NINE MILE POINT
NUCLEAR STATION

SUBJECT: Nine Mile Point Nuclear Station
Unit No. 2; Docket No. 50-410

Response to Request for Additional Information Regarding Nine Mile Point Nuclear Station, Unit No. 2 – Re: The License Amendment Request for Extended Power Uprate Operation (TAC No. ME1476) – Steam Dryer

Figure RAI-8 S01 (b) – 1 - Low power coherence.

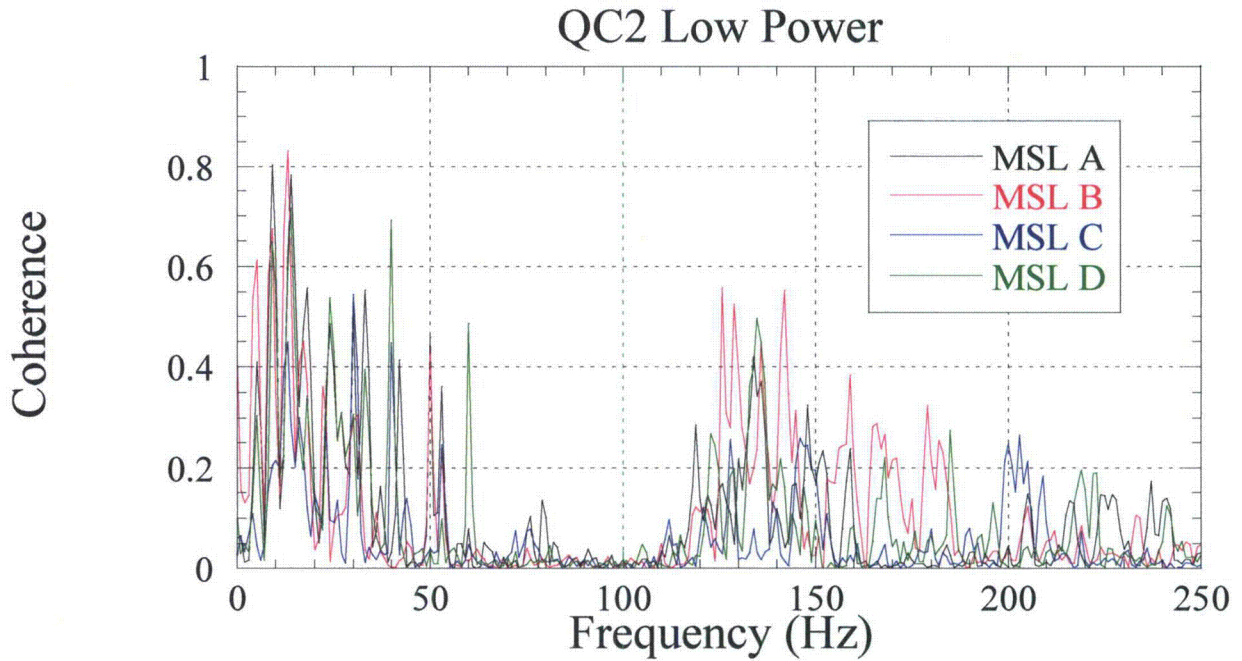
The procedure used to estimate [[]] is based on the assumption that the [[]]. The applicant is requested to provide plots of the [[]] at the low power level used in the Quad Cities Unit No. 2 (QC2) benchmark. If the [[]] are not nearly zero, the applicant should justify their assumption that the low power measurements are [[]]. The applicant is requested to provide the same information for the NMP2 calculations.

Figure RAI-8 S01 (b) - 1 and Figure RAI-8 S01 (b) - 2 show the coherences for the low power signals used in QC2 and NMP2, as requested. The coherence analysis is described in Section 5.1 of CDI Report No. 10-09P, Rev. 1 (submitted by NMPNS letter dated June 30, 2010).

The coherence between upper and lower strain gage arrays from the MSL of QC2 and NMP2 at low power conditions is shown in Figure RAI-8 S01 (b) - 1. [[

]] The strain gages show an average coherence of approximately 0.4. [[]] The coherence in the present analysis is only used to scale the reduction of upper and lower MSL measurements and errors associated with this scaling are accounted for in the bias and uncertainty and added back into the pressure loading.

Figure RAI-20 S01 - 1 - Displacement of ribbed (Model A) and uniform (Model B) plates under rigid transverse forcing.

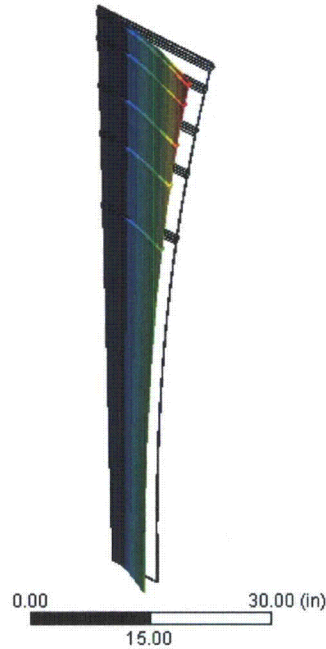
As mentioned in Appendix A of the CDI Report 09-26P, the closure plate modification includes the addition of stiffening ribs on the plate. In the finite element analysis, the modified closure plate is modeled by a thicker closure plate, which is dynamically equivalent for the fundamental mode of in-plane vibrations. The fundamental frequency of the modified plate is 256.0 Hz. The applicant develops [[

]]]. Since the frequencies representing bending, and torsional modes of the modified closure plate will be [[]], in the development of the unit solutions considered here, the modified closure plate will behave statically as far as bending and torsional deformation of the closure plate is concerned. However, the finite element model of the modified closure plate is statically not equivalent to the closure plate modified with ribs. The licensee is requested to evaluate the errors introduced by this inconsistency in the steam dryer stresses at CLTP.

A deficiency raised in the RAI is that while the plate has been adjusted to be dynamically equivalent, static equivalence is not necessarily demonstrated. To quantify this deficiency, a series of static calculations was carried out to compare the stiffness of the reinforced closure plate with the ribs explicitly modeled against the stiffness of the modified and dynamically equivalent plate described above. In these calculations, the closure plate was cantilevered on its vertical straight edge (the one connected to the vane bank in the steam dryer), and the curved edge (the one connected to the hood in the steam dryer) was subjected to a distributed: (i) 10 lbf net transverse force and (ii) 10 lbf-in net moment. These are the dominant forces expected from relative vane bank motions in the dryer (these motions are associated with a twisting of the upper support ring which in turn is due to the non-symmetric positions of the steam dryer supports).

These loads are applied to the closure plate with explicitly modeled stiffening ribs (Model A) and a closure plate without ribs, but with an altered thickness (Model B). Since the same load is applied to each model, the calculated maximum displacement provides a measure of the static stiffness that the closure plate presents to the steam dryer. The displacements resulting when these forces are applied to each model are shown in Figure RAI-20 S01 - 1.

Table RAI-20 S01 -1 shows the maximum displacements obtained with each model. For Model B the plate thickness is adjusted to match the maximum displacement of the explicitly modeled rib structure (Model A). The tabulated results show that the effective thickness range is 0.245"-0.270" with an average value at 0.258". This agrees very closely (to within 1.2%) with the 0.255" effective thickness used in the steam dryer model. The errors incurred in utilizing the uniform plate approximation are compensated for by the frequency shifting required in dynamic analysis (this will address differences in predicted mode frequencies) and the bias (25.26%) inferred from the Hope Creek shaker test representing differences between the actual and modeled dryer due to modeling idealizations.

To summarize, a uniform plate with thickness 0.258" most accurately reproduces the static deflections obtained for a closure plate with explicitly modeled stiffening ribs. This thickness closely matches the value (0.255") used for the closure plate in the steam dryer analysis. Thus, for engineering analysis purposes, the closure plate modeled in the steam dryer is statically similar (to within 1.2%) to the actual plate with the ribs explicitly accounted for. In addition, the closure plate used in the steam dryer is dynamically equivalent to the actual rib-reinforced closure plate in terms of the matched modal frequencies. Taken in combination, these observations imply that the closure plate representation in the steam dryer analysis is both statically and dynamically equivalent to the rib-reinforced structure in the 0 - 250 Hz frequency range.

Figure RAI-21 S01 - 4 - The high resolution stress distribution extracted from the global steam dryer model and applied as element forces (top) and moments (bottom) to the solid sub-model.

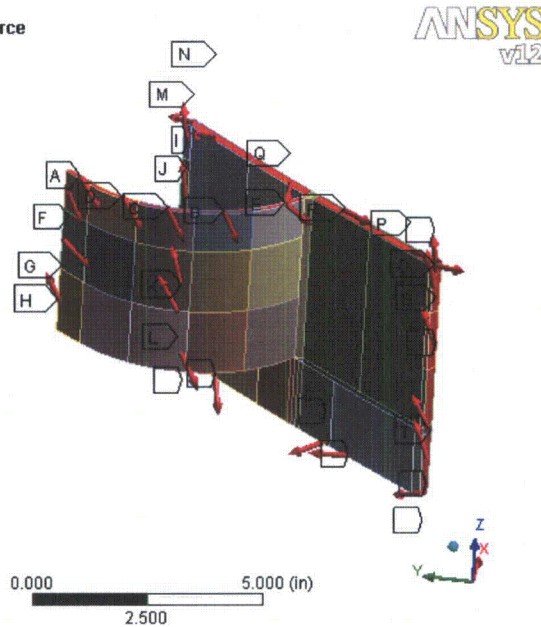
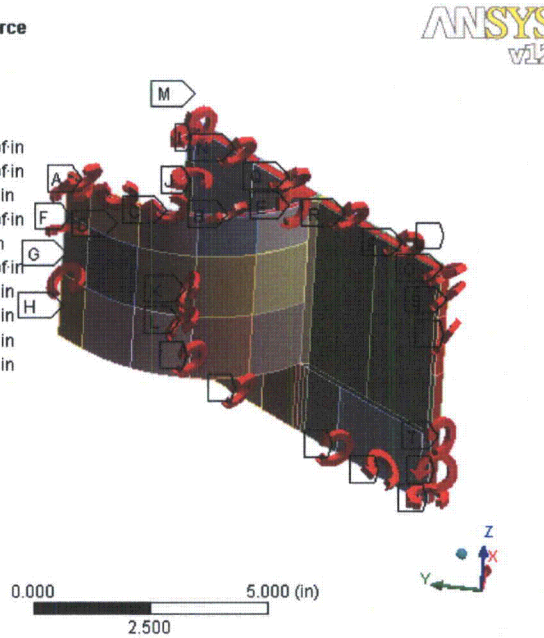
The applicant states that the submodeling procedure, which is applied to the modified closure plate, is designed to produce more accurate estimates of the stress field in the vicinity of the weld location of interest. The applicant further states that as one moves away from this location, the stress field in the submodel including the portion along its intersection lines (cut boundaries) deviates from the global model for two reasons: (1) cut boundary is near another structural discontinuity, and (2) the matching between the stress components in the global model and submodel is carried out near the weld location rather than near the submodel perimeter including cut boundaries. The applicant also states that locating the cut boundaries too far away will compromise the validity of the linearly varying body force distribution used to account for inertial effects and acoustic loads. While the NRC staff notes the difficulties involved in applying submodeling approach in this specific case, it is obvious that the approach used here is not a valid one because the stress field at the cut boundaries deviates as the mesh is refined and, therefore, the accuracy of the stress results obtained cannot be assessed. The cut boundaries shall be taken sufficiently far enough away from the high-gradient, localized stress locations (such as weld) to ensure the accuracy of the stress results obtained using the refined mesh. The applicant is requested to evaluate the applicability of its submodeling approach to the subject weld. The approach, if used, may be revised such that (1) the mesh refinement at the weld produces local changes to stresses and strains, while stresses and displacement at the cut boundaries remain unchanged, and (2) the body force distribution is properly considered.

There are several statements in this RAI that suggest that some key aspects of the sub-modeling methodology have not been clearly conveyed. During the NMPNS presentation to the NRC staff on September 23, 2010, a review of the overall sub-modeling procedure was given which helped identify the specific technical concerns. Therefore, in the response below, a summary of the sub-modeling steps (similar to that in the September 23, 2010 presentation) is provided. This summary clarifies the motivation for, and technical consistency of, the sub-modeling methodology adopted by CDI. This is followed by responses to the specific questions raised in the RAI supported by numerical calculations using the drain channel/skirt sub-model considered in CDI Report No. 10-12P.

The stress reduction factors and the linearized stresses along the contributing paths are given in Table RAI-21 S01 - 1 for each of the calculations, C0 to C2. Also, the percent differences between these results are listed. The main observation is that both the linearized stresses and the stress reduction factors are all in close agreement. The maximum difference between the linearized stresses is 5.2%, whereas the maximum difference between the stress reduction factors is 3.8%. As explained above, these differences are all attributable to finite mesh size and sub-model size and the differences are well within the bias error associated with mesh discretization (9.53%).
